Engineering - Final Plat Checklist

9. C. Final Plat

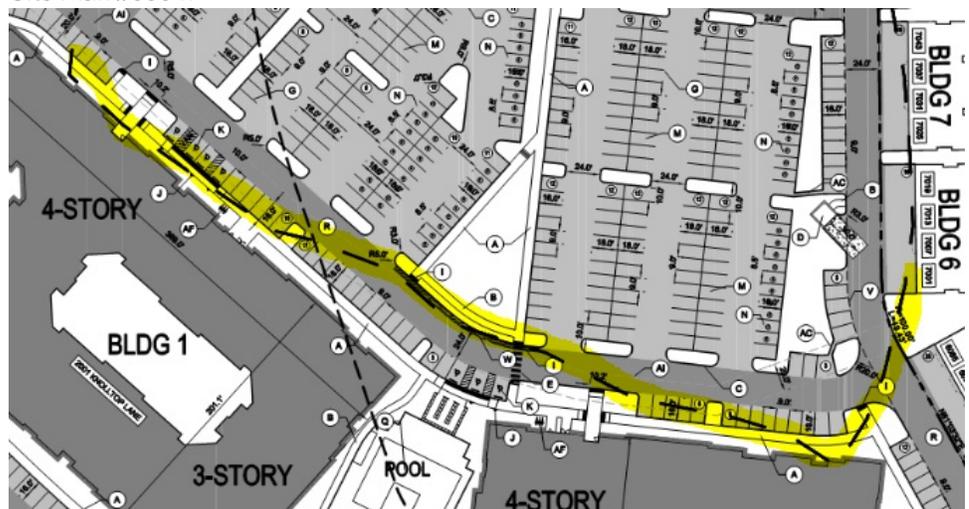
lance.fittro@franklintn.gov Applicant to verify location of landfill boundary vs. the proposed location of the buildings on Lot 2. As depicted, the landfill limits will extend into the footprint of the proposed buildings, but the Site Plan for Lot 2 (COF #6394) showed no overlap.

lance.fittro@franklintn.gov The previous comment, "Applicant to verify location of landfill boundary vs. the proposed location of the buildings on Lot 2. As depicted, the landfill limits will extend into the footprint of the proposed buildings, but the Site Plan for Lot 2 (COF #6394) showed no overlap." has not been addressed.

brad.thomas@bwsc.net This item is under review, and research is being performed to verify the location of the landfill.

Applicant shall show the landfill limits such that there is no overlap between the landfill limits and the building footprints as indicated on the approved Site Plan.
[Edited By Lance Fittro]
